Subject: KEYLESS ENTRY SYSTEM - DOORS CANNOT BE LOCKED/UNLOCKED USING TRANSMITTER - BATTERY IS OK	Bulletin No: 09-035/06
	Last Issued: 8/14/2006

2006 Mazda5 vehicles with VINs lower than JM1 CR**** ** 123133 (produced before March 1, 2006)

2006 MX-5 vehicles w/o Advanced Keyless with VINs lower than JM1 NC**** ** 115201 (produced before March 1, 2006)

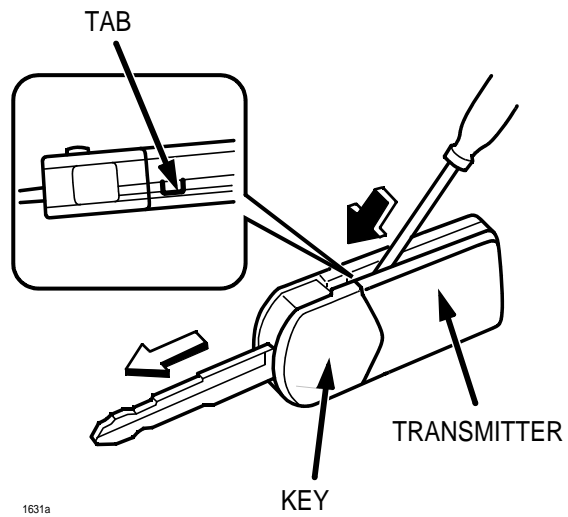
Some vehicles may experience that the doors cannot be locked / unlocked, trunk cannot be opened (MX-5) and panic alarm cannot be activated. The transmitter battery is found to be good. The negative terminal inside of the transmitter contacting the battery is deformed, causing poor contact.

As a mass-production change, the shape of negative terminal in the transmitter has been changed. Customers having this concern should have their vehicle repaired using the following repair procedure.
